UNEP/OzL.Pro/ExCom/73/54/Add.1
31 October 2014

Addendum

REPORT ON THE MULTILATERAL FUND CLIMATE IMPACT INDICATOR (DECISION 69/23)

Review of the Multilateral Fund Climate Impact Indicator (MCII)

Total lifetime climate impact of one year of production [tCO2e]

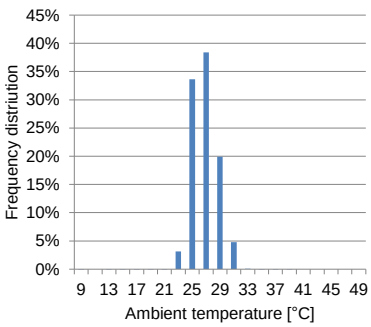
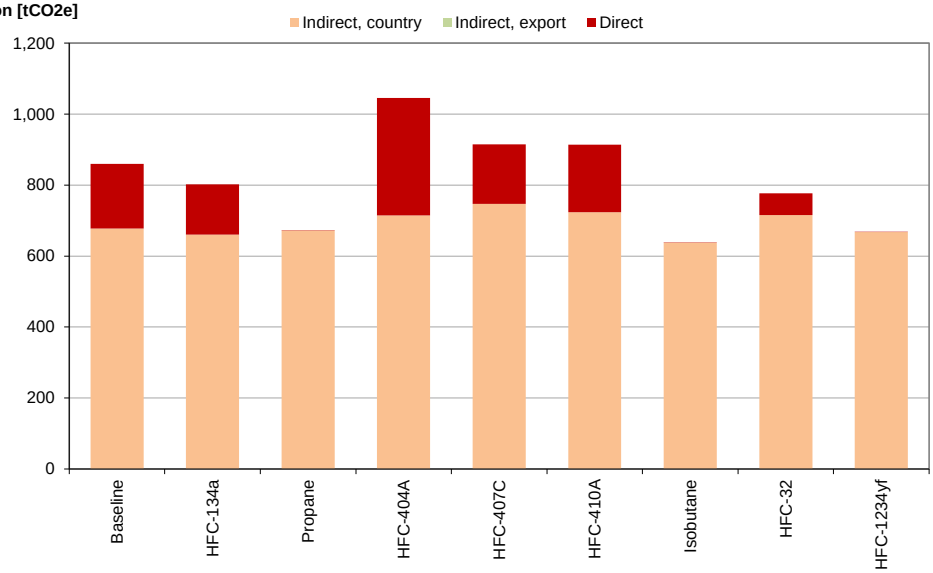
To review results generated by MCII, I performed an analysis for an air-conditioning unit in Seychelles (attached). My observation is that the obtained results on indirect impact for different fluids are not correct to a degree that will provide incorrect relative rankings of alternative fluids.

The MCII analysis shows that the transition from R22 to isobutane and R-1234yf will results in a reduced indirect effect, i.e., improved equipment efficiency. On the other hand, transition from R22 to R410A and R32 will result in an efficiency decrease, while a change from R22 to propane will be efficiency neutral. These results correlate with critical temperatures of the analyzed fluids (fluids with a lower T_{crit} (R410A and R32) have a lower efficiency than fluids with a high T_{crit} (R134a, isobutene and R1234yf); because of the modeling methodology they may correctly represent relative performance of these fluids in chiller systems employing shell-and-tube heat exchangers (pool-boiling and space-condensation refrigerant heat transfer).

However, the obtained results are in disagreement with the current recognition of relative merits of refrigerants applied in systems using optimized serpentine heat exchangers (forced convection evaporation and condensation heat transfer), such as residential and small commercial units. To start with propane, the literature is full of claims of propane having a 5 % - 10 % better efficiency than R22[2]. Regarding R410A, the industry learned to optimize R410A heat exchangers and to match COP_{R22} with R410A systems. Our 2006 study[3] confirmed the COP equivalency between R22 and R410A. It also indicated that R134a and isobutene will underperform R22, propane and R410A in an optimized system (when transport properties and system effects are accounted for), while the MCII model predicts isobutene and R134a to be the most efficient fluids.

A general observation is that high-pressure fluids (such as R32 and R410A) have a lower dT_{sat}/dP (lower drop of saturation temperature for a given pressure drop). It means that these refrigerants can be used with a higher mass flux in heat exchangers for a given drop in saturation temperature; a higher mass flux improves the refrigerant heat transfer coefficient[4]. Obviously, transport properties (chiefly liquid thermal conductivity and viscosity) also affect performance of heat exchangers as demonstrated by propane, which T_{crit} (and normal boiling point) is not much different than that for R22.

In conclusions, I believe that the MCII overrates low-pressure fluids (such as R134a, isobutane, and R1234yf) and underrates high-pressure fluids (R410A, R404A, and R32) by not considering the dT_{sat}/dP relationship.
Besides the dT_{sat}/dP consideration, isobutane, propane, and R32 would gain some benefit if the MCII included transport properties in the analysis.
